# SAN FRANCISCO PLANNING DEPARTMENT

**MEMO**

**RE:** **Review and Comment on work proposed to abate Planning Enforcement Case No. 2017-015635ENF, addressing work completed without a Certificate of Appropriateness and proposed expansion of a penthouse and addition of a roof deck and gate, Case No. 2018-009197COA.**

**Re: 1470 McAllister Street**  
**Planning Case No.: 2018-009197COA**  
**Hearing Date: March 6, 2019**  
**Our File No.: 10403.02**

5 AS BUILT FRONT ELEVATION WITH PROPOSED ROOF DECK, ROOF CORNICE, DRIVEWAY GATE AND PILLARS

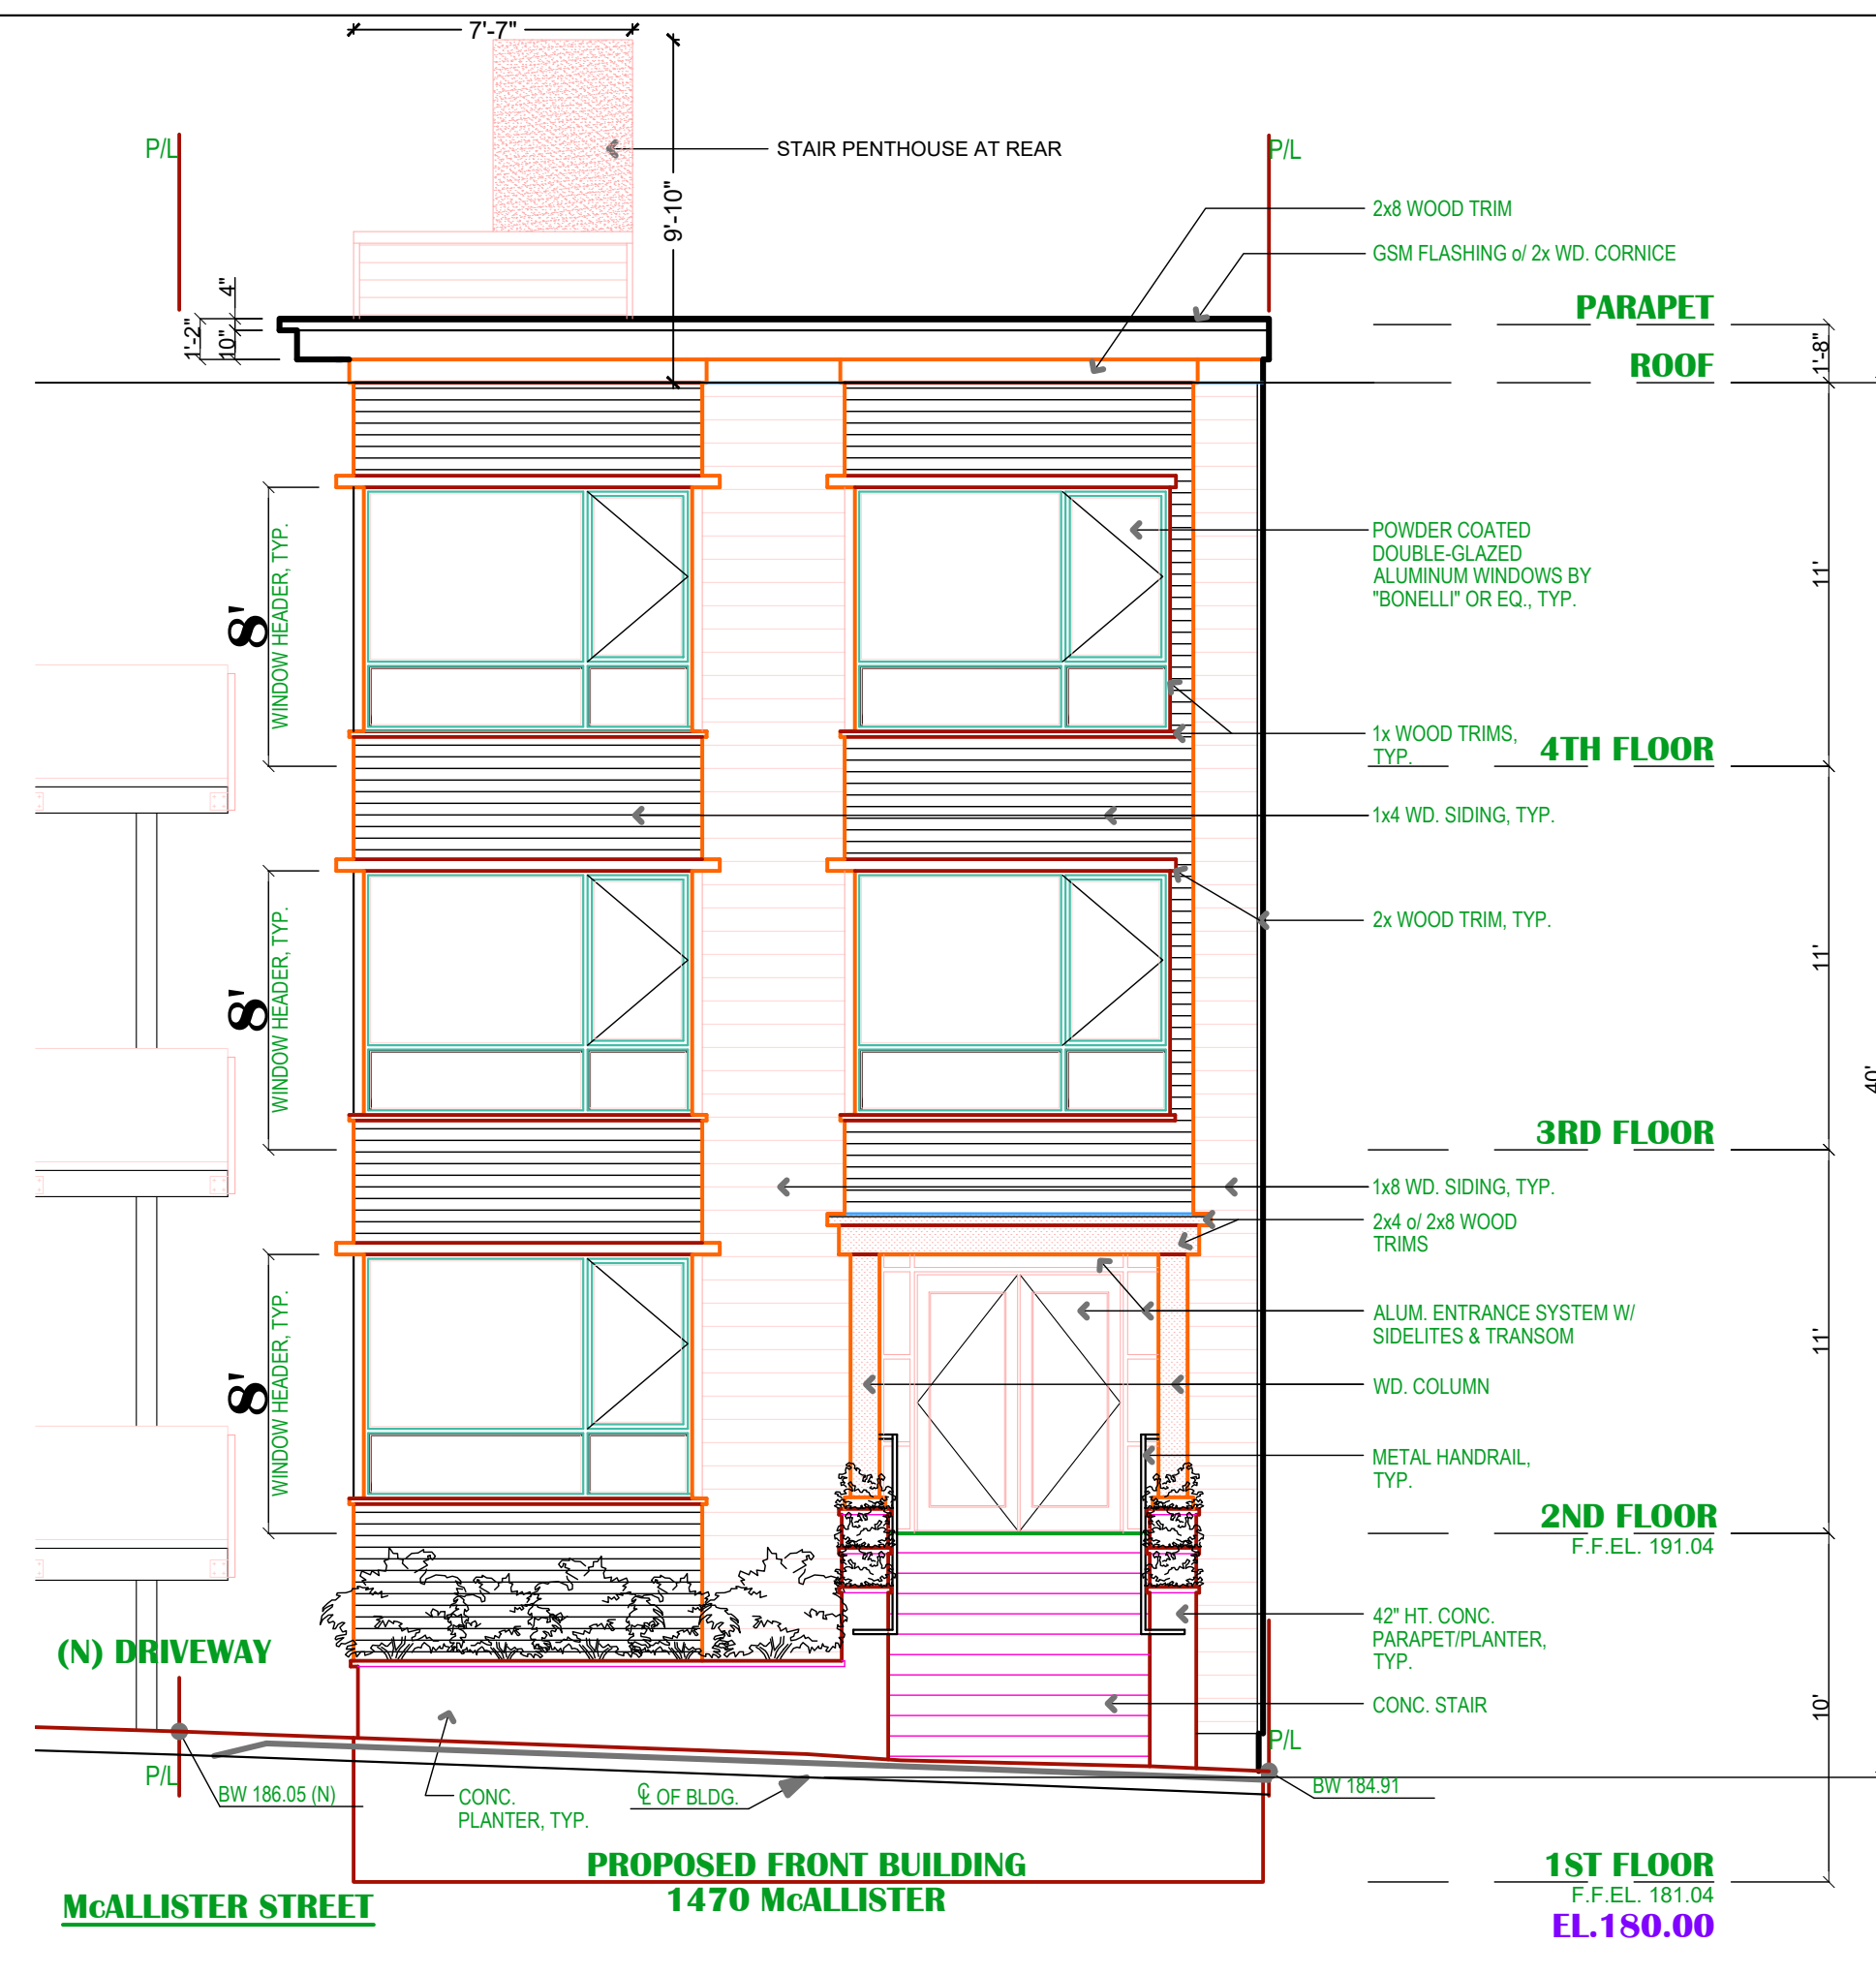
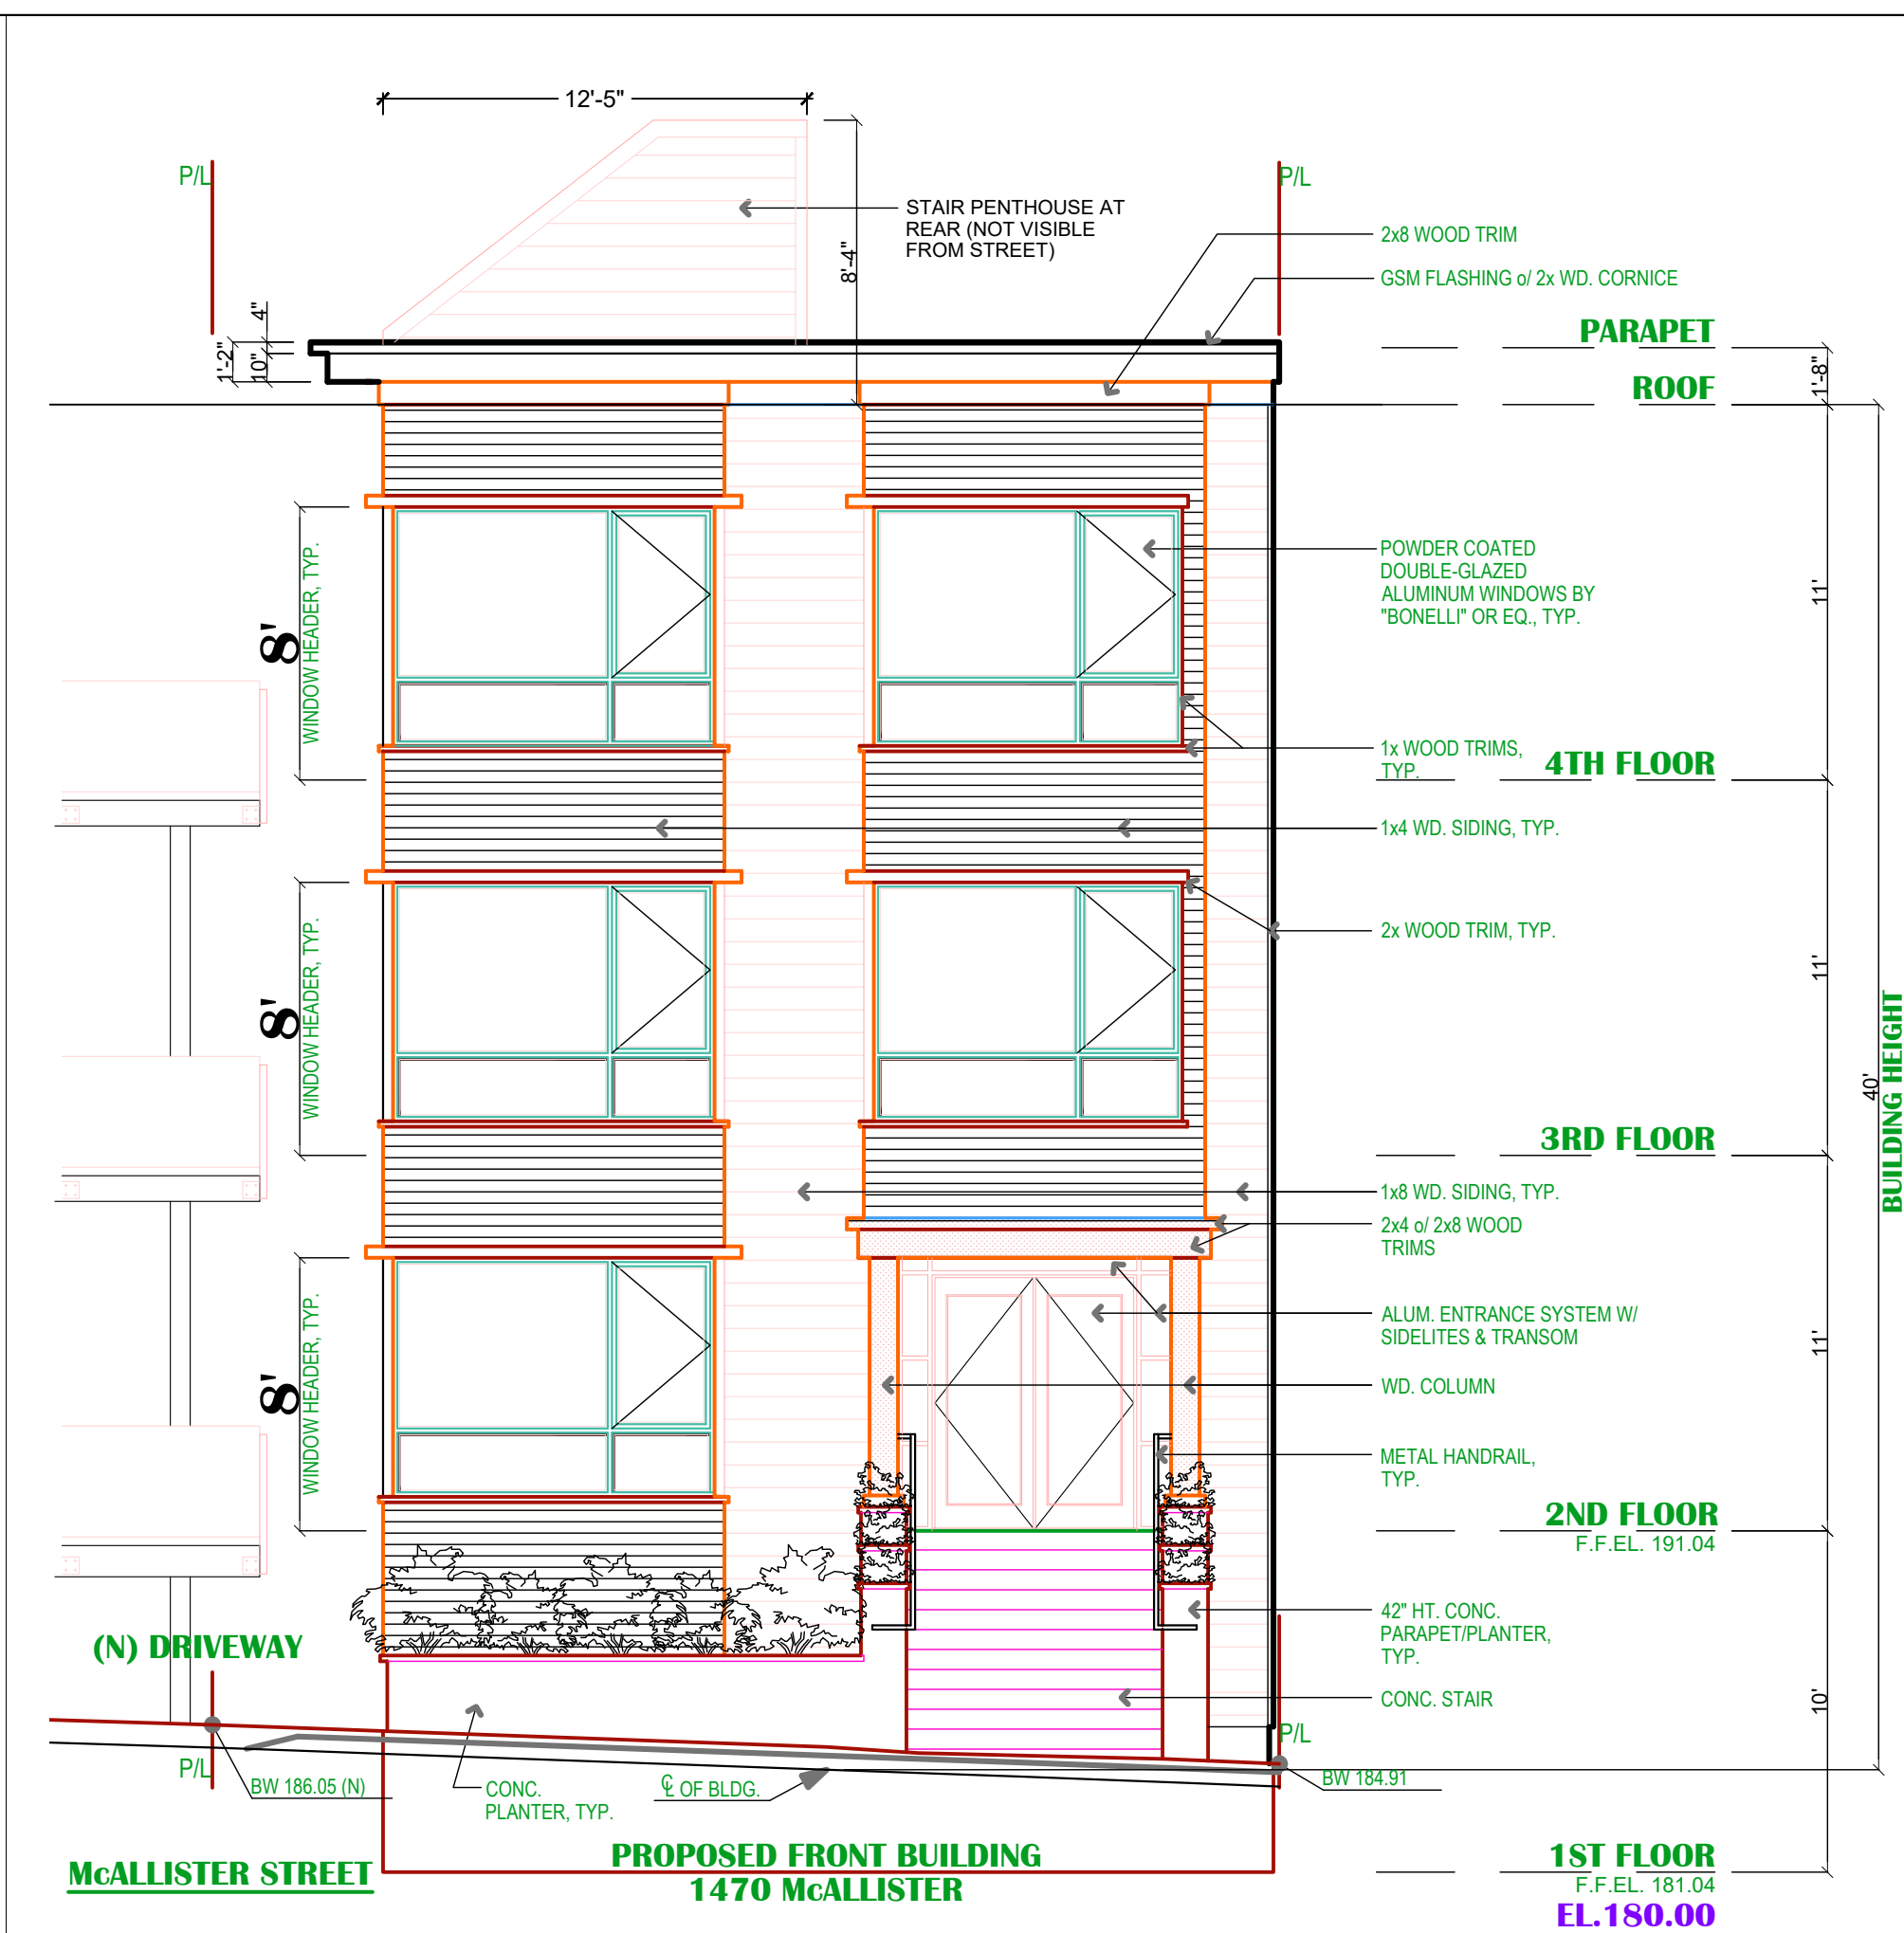
**Roof Cornice:** The building currently does not have a cornice, which is incompatible with the intense ornamentation found in the district. The proposed wood cornice is contemporary in form and detailing, and is reflective of the multi-stepped form of cornices in the district. It is also similar in its proportions and projection to cornices in the district. The proposed cornice will cap the building in a manner more similar to the rooflines found in the surrounding historic buildings. The Department recommends that a section detail of the cornice element be submitted for final design review.

**Window Trim:** The building currently employs no ornamentation, which is incompatible with the highly ornamented wood facades of the district. The proposed addition of raised wood horizontal trim above windows would make the façade multi-planar and provide some play of shade and shadow similar to that achieved at historic facades.

**Recommendation:** The Department recommends the finish, materials and dimensions of the gate be called out on plans to better analyze its compatibility with the district.
